SAXTON NUCLEAR EXPERIMENTAL CORPORATION

DOCKET NO. 50-146  
LICENSE DPR-4

-----  
Change Request #20  
-----

FIGURE 1  
PRIMARY COOLANT FLOW  
COASTDOWN FOLLOWING LOSS  
OF PUMP POWER

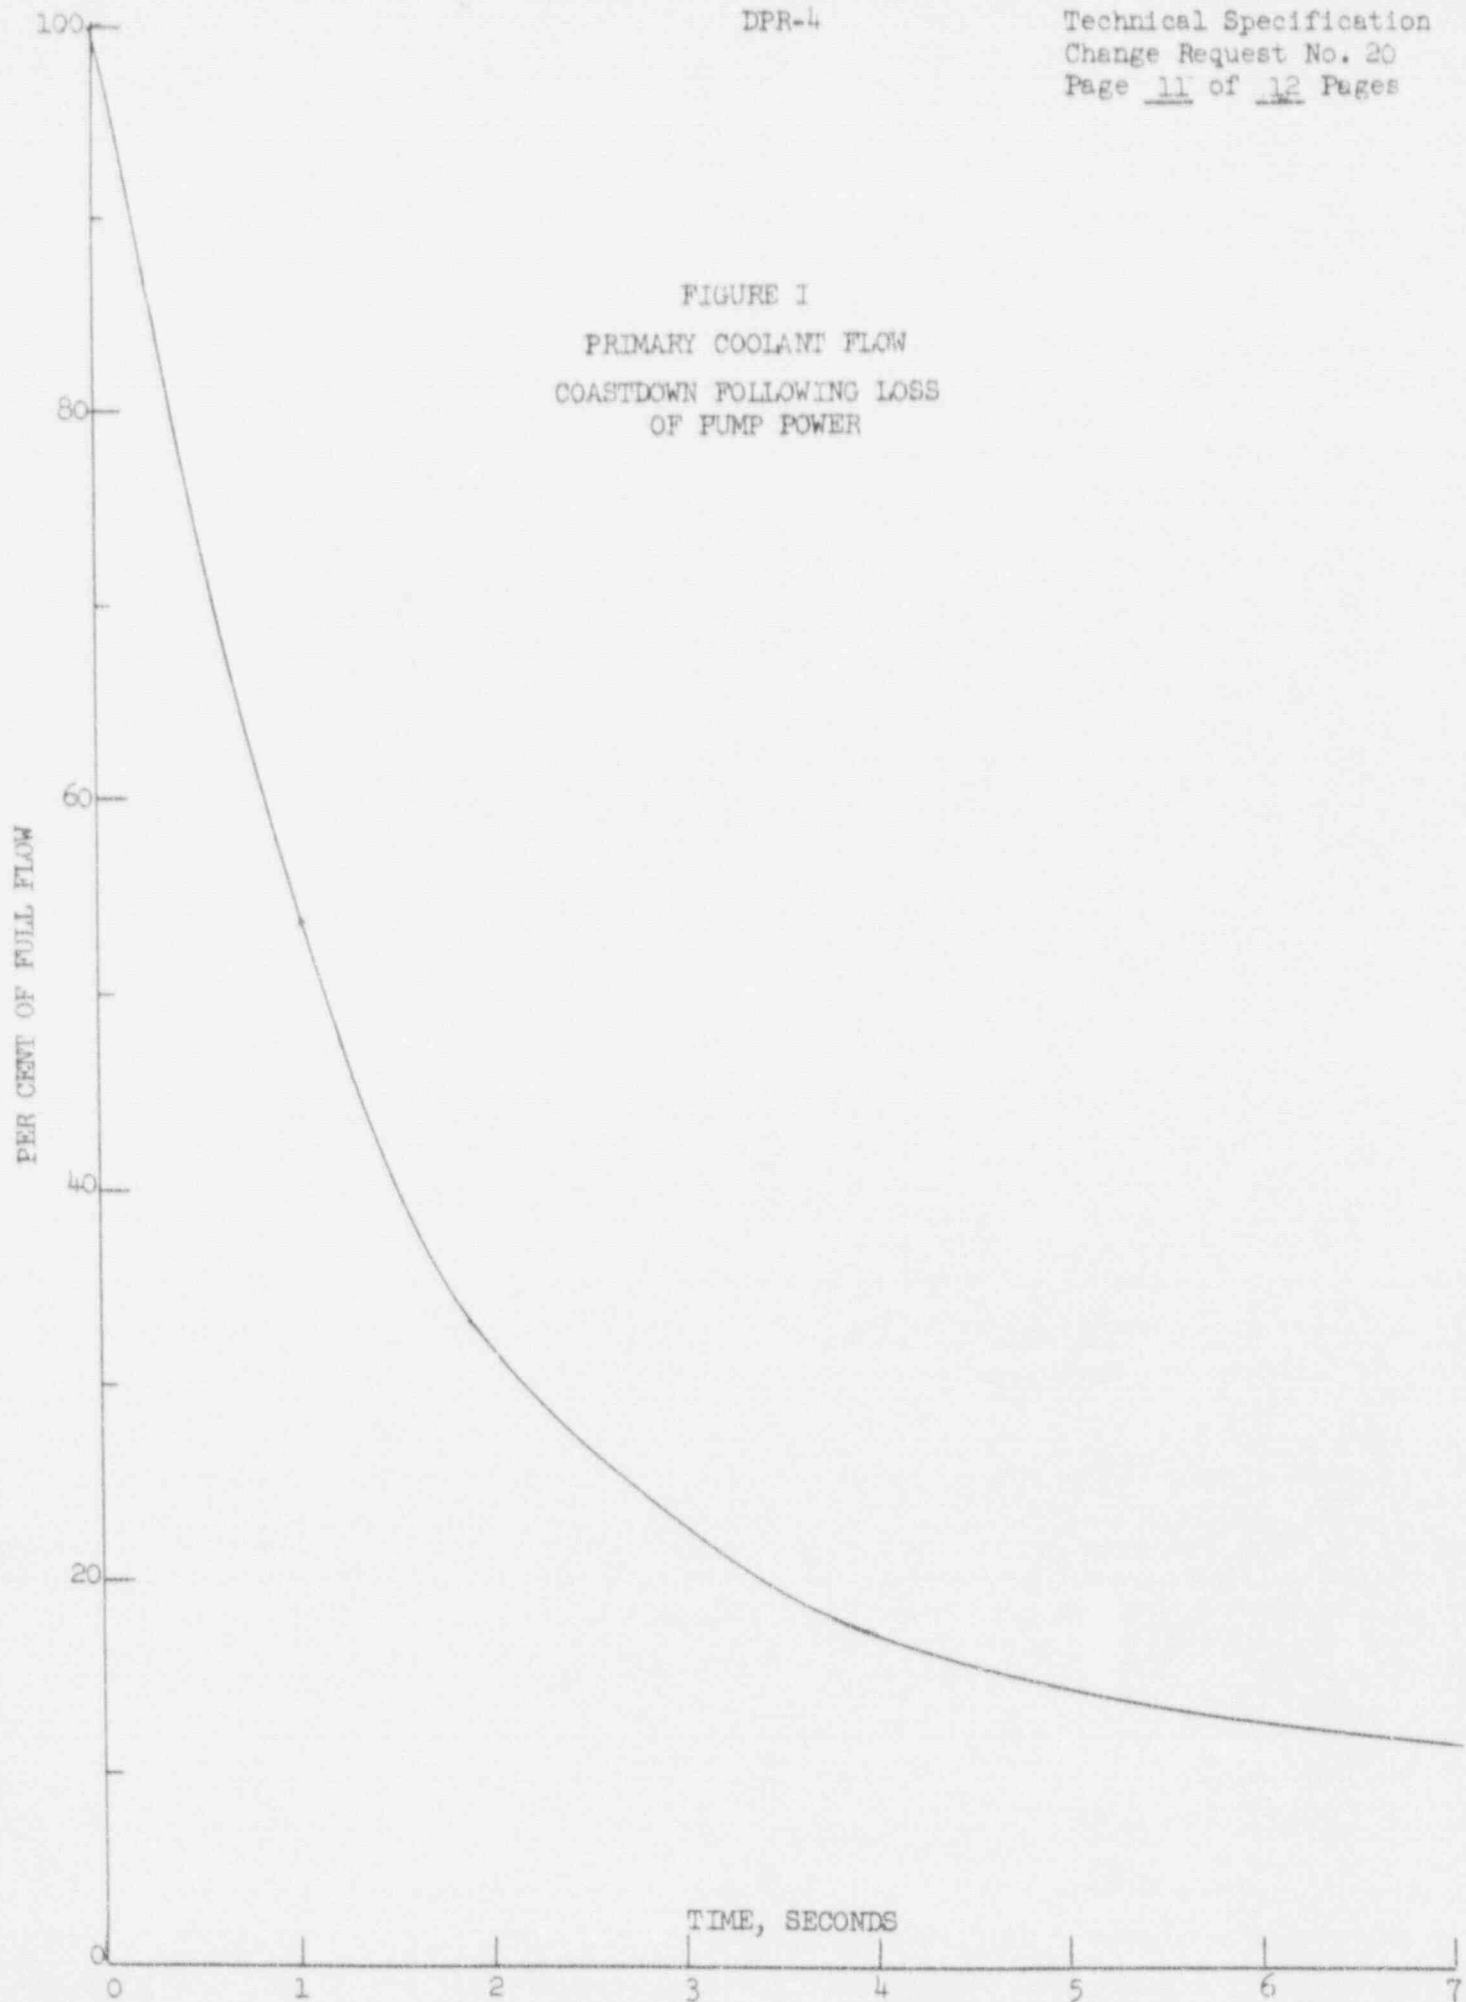
The loss of flow accident was assumed to occur due to a loss of pump power and the flow coastdown curve of the main coolant pump is given in Figure I. The reactor and 2x2 parameters that were assumed for the accident are presented in Table 4. Reactor scram is assumed to start 1.5 seconds after the beginning of the accident and is completed at 2.4 seconds. The delay in scram initiation and completion is due to:

DNB RATIOS DURING LOSS OF COOLANT FLOW  
ACCIDENT, SAXTON 2 X 2 ASSEMBLY

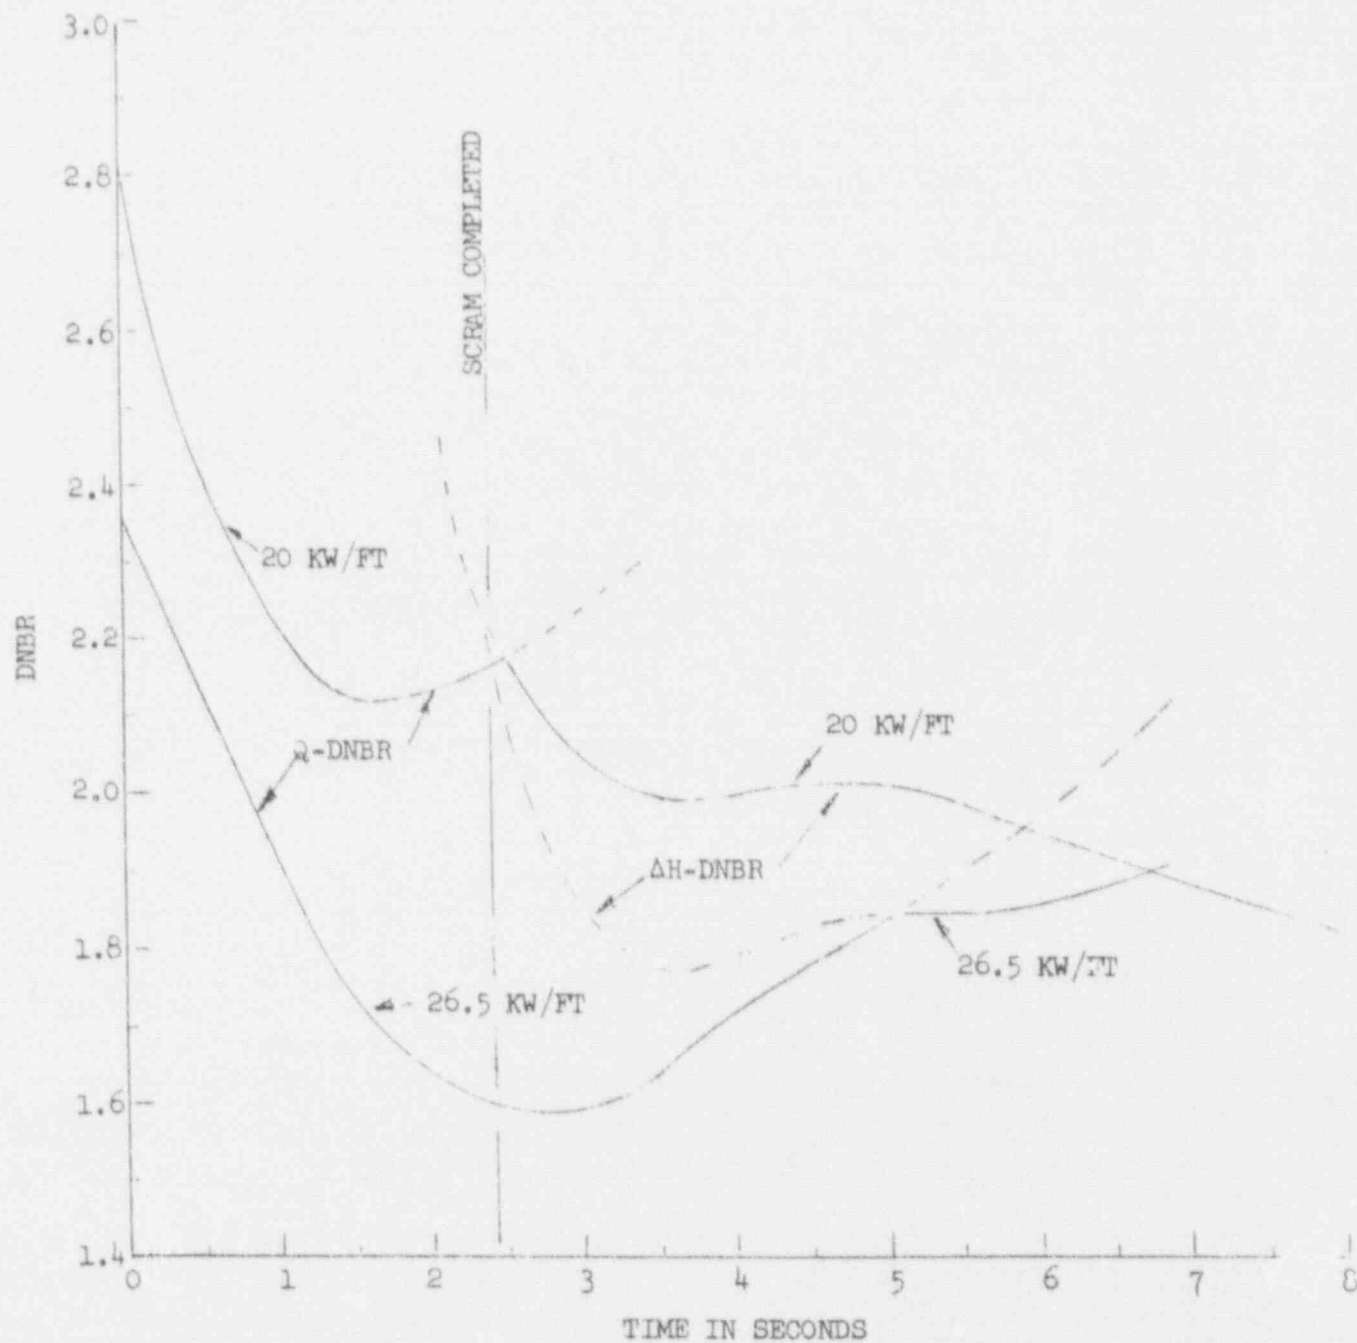
The results of the loss of flow analysis are presented in Figure II and compared with the results for the previous analysis presented in Addendum 1. For the 26.5 kw/ft operation, the minimum DNB ratio is a Q-DNBR of 1.59 that occurs at 2.7 seconds after the start of the accident. The Q-DNBR was evaluated assuming a reactor coolant pressure of 1950 psia which is conservative as the Q-DNBR decreases with decreasing pressure.
